PROPOSED HOUSING DEVELOPMENT AT
COLLINS AVENUE, DUBLIN

Stage 1 Quality Audit

(Incorporating a DMURS Street Design Audit, and Audits
of Accessibility, Cycling, Walking and Road Safety)

Figure 5.4 – Visibility Splay interrupted by tree

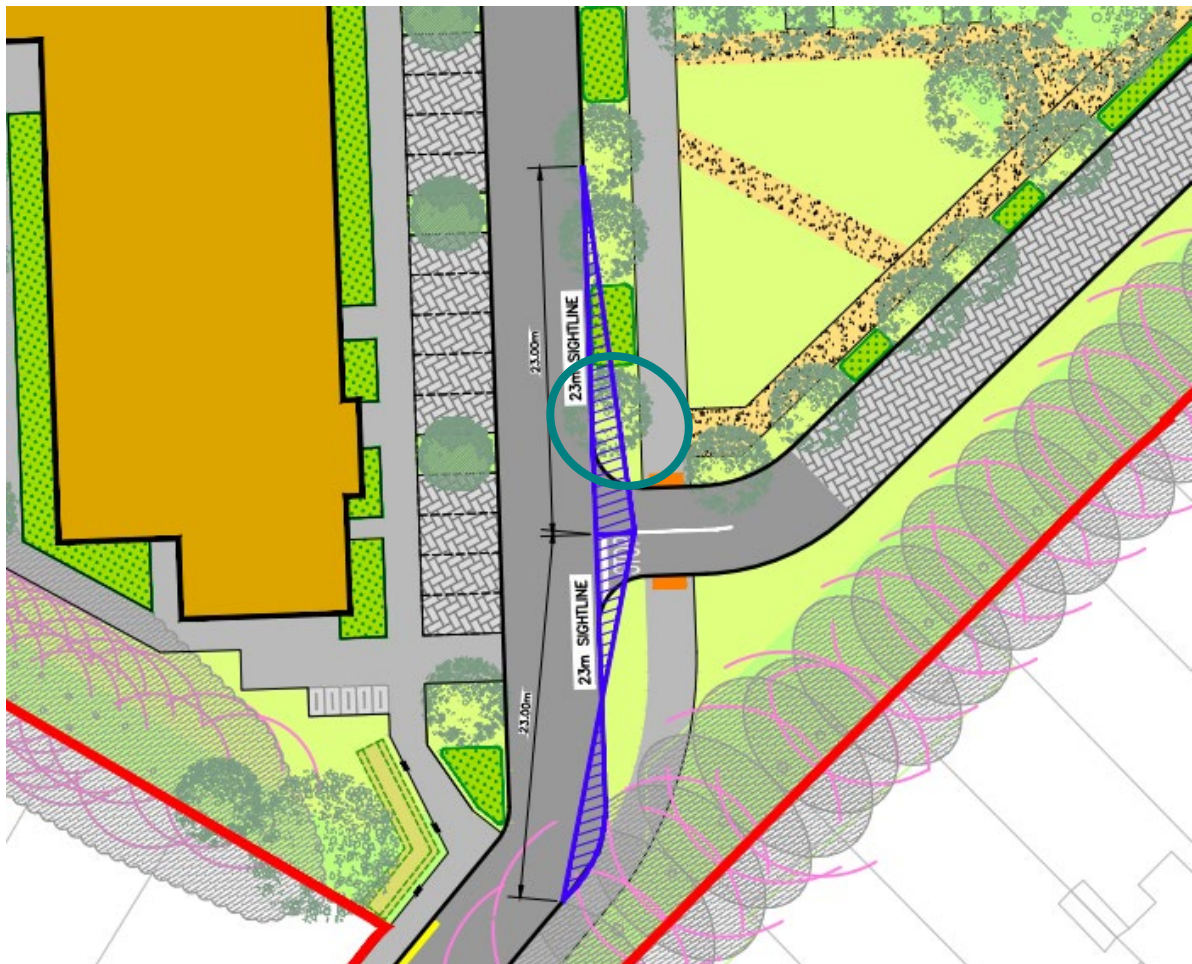
Sightlines at the priority junction in Figure 5.4 appears to be interrupted by a tree. This may increase the likelihood of vehicle collisions due to the reduced sightlines created by this tree.

Ensure adequate visibility splays at all junctions from edge of carriageway. Remove trees or any other obstructions from visibility splays.

Figure 5.5 – Stopping Sight Distance compromised

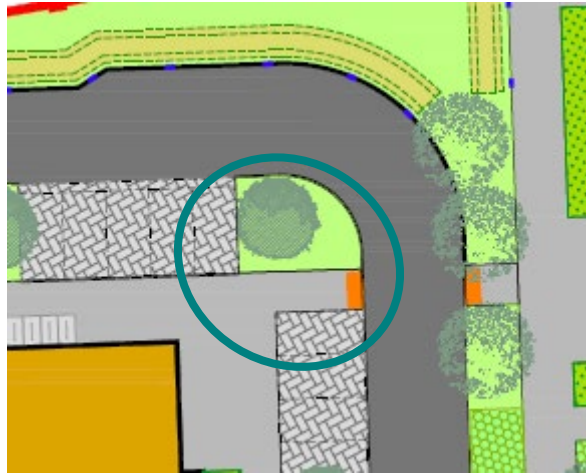
The stopping sight distance (for vehicles approaching from the south) may be obstructed by a proposed tree and parked vehicles (Figure 5.5), which may compromise visibility. This may increase the likelihood of vehicle collisions due to the reduced sightlines. Visibility of pedestrians approaching the priority crossing may also be obscured, potentially causing injuries for users.

Ensure adequate stopping sight distance along all roadways, particularly at corners.

Figure 5.6 – Visibility splay at turnabout junction

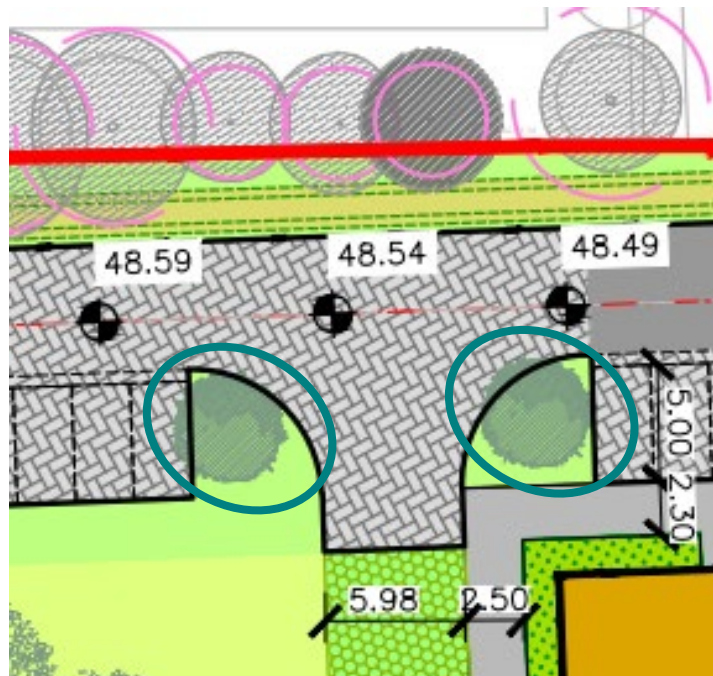
The sightlines at the turnabout junction in Figure 5.6 may be compromised by the adjacent trees. This may increase the likelihood of collisions at this location, especially for drivers of vehicles turning / reversing and an associated greater risk of blind spots in these manoeuvres. It is not clear where the visibility splay should be or if it is adequate. Incomplete visibility splays can give rise to sudden braking or vehicle collisions.

Visibility splays should be assessed for this turning area.

Figure 6.2 – Incomplete pedestrian desire line

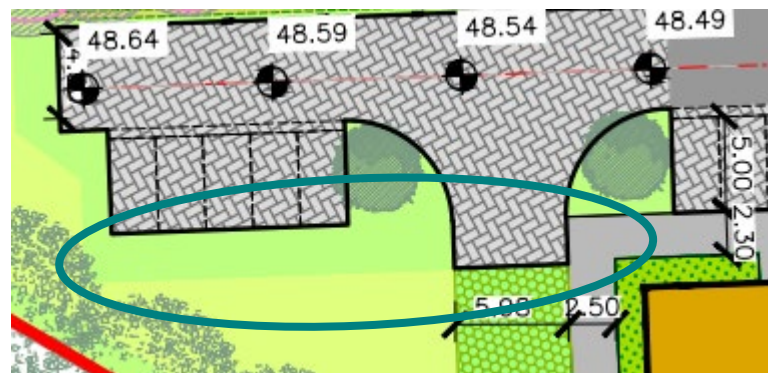
A pedestrian desire line (Figure 6.3), to access parking in the northwest corner of the development, is incomplete, forcing pedestrians to walk onto the roadway, at a turnabout location, to access the last parking bays. This may increase the likelihood of pedestrians being struck by moving vehicles or pedestrians walking along the grassed areas and slipping during rainfall.

Figure 7.1 – Traffic Calming Island and Stop-Go with Cycleway bypass

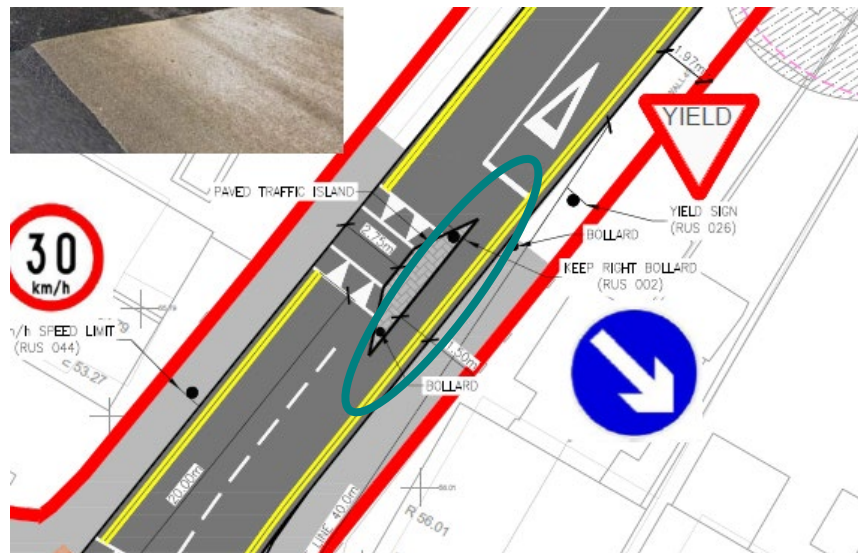
A proposed stop-go ramped traffic calming system features a cycleway bypass (Figure 7.1). This bypass may be subjected to the build-up of leaves from proposed/nearby trees and silt etc. This may increase the likelihood of slipping/skiddy for cyclists if it is not maintained and a standard road sweeper won't fit behind the traffic island.

Figure 7.2 – GDA Cycle Network (www.nationaltransport.ie/wp-content/uploads/2023/01/2022-GDA-Cycle-Network.pdf)

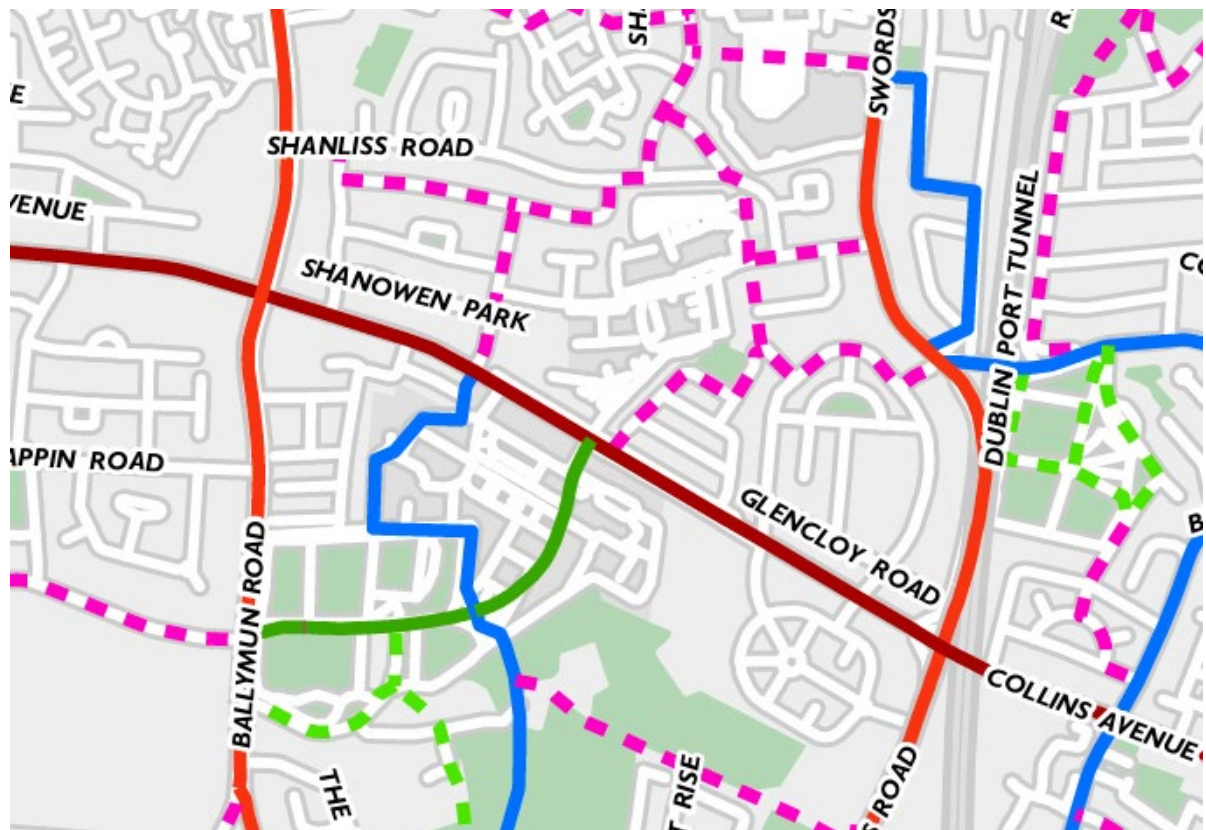
While there is no proposed cycle infrastructure in the development, the local DMURS type street adopted is intended to be a low-speed environment. It is not clear however how the development will tie into the proposed 'Primary Orbital' Cycle Route (dark red in Figure 7.2) along Collina Avenue, the 'Utility Greenway' Route (green in Figure 7.2) coming from DCU opposite the development entrance, or the 'Feeder' Route (dashed pink line in Figure 7.2) from the laneway (immediately east of the development entrance) connecting to Crestfield Close. A lack of coordination may reduce the effectiveness of these schemes, proposed by Dublin City Council and National Transport Authority, and undermine potential to achieve cyclist desire lines.

Figure 8.1 – Proposed raised crossing location

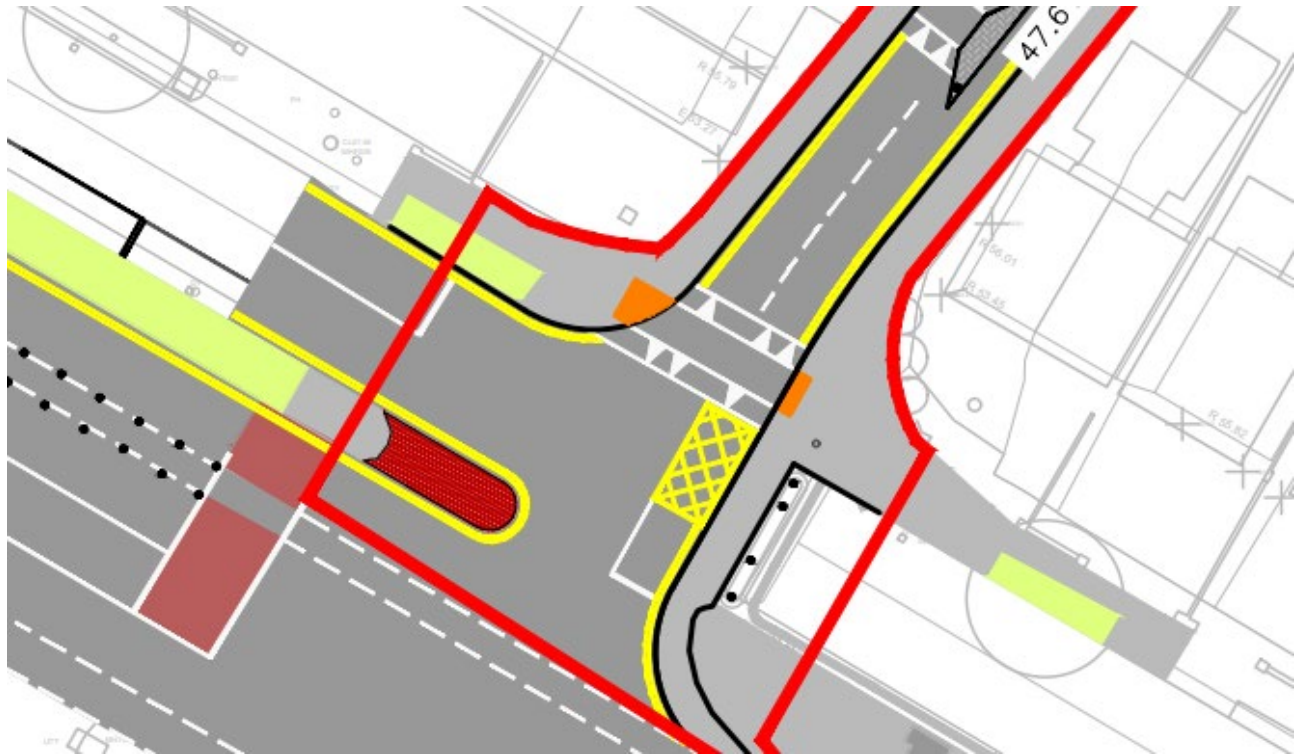
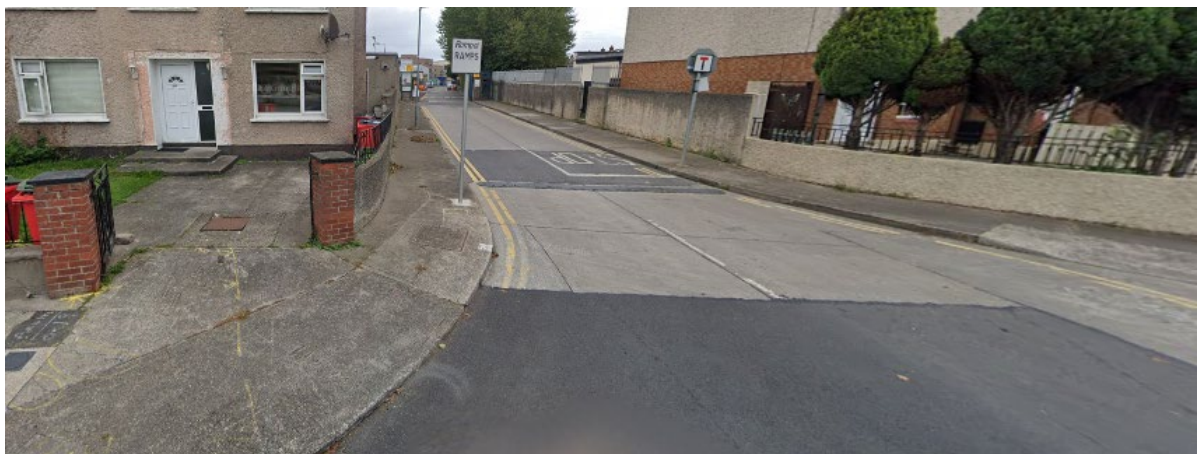
At the approximate location of the proposed raised crossing (Figure 8.1) there is a vehicular entrance. The proposed location of the associated tactile paving may be damaged by vehicular overrun associated with this driveway due to its location. This may cause tactile pavers to crack with an associated tripping hazard.

Figure 8.8 – Pedestrian Facilities

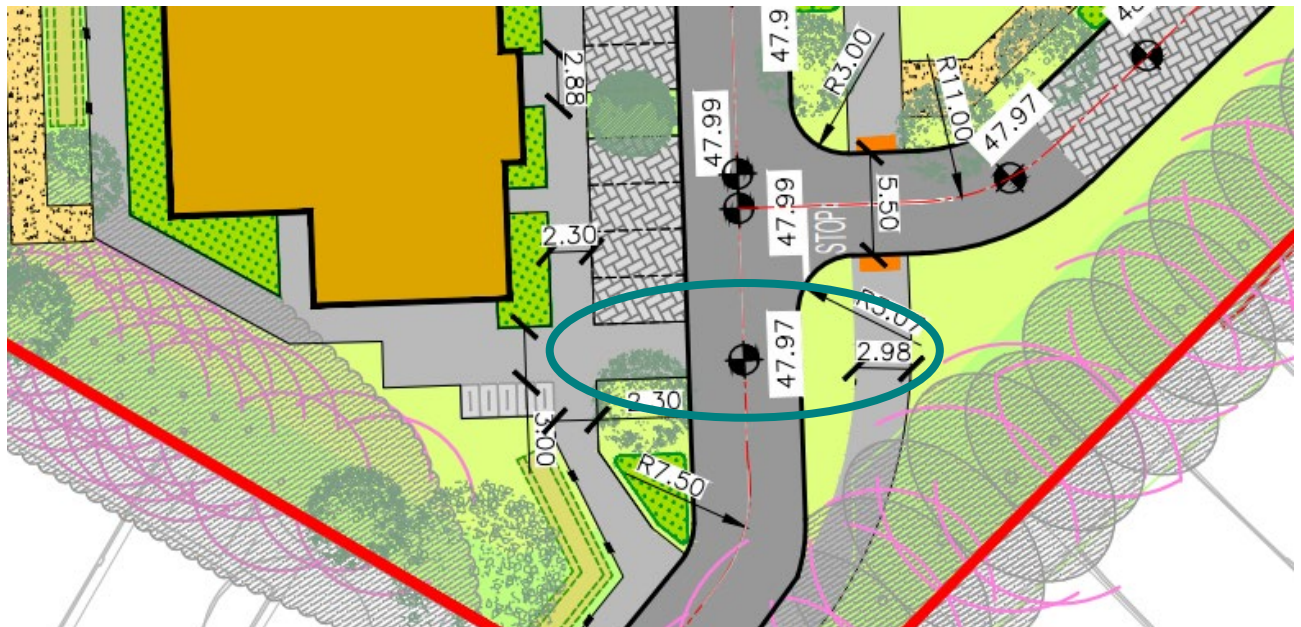
The T-junction in Figure 8.8 is incomplete for pedestrian movements, and it is not clear how pedestrians, especially with a vision impairment, will follow it and meet the other side.

Provide suitable pedestrian crossing facilities such as dropped kerbs, tactile paving and footpath links to accommodate pedestrians crossing east west at this location.
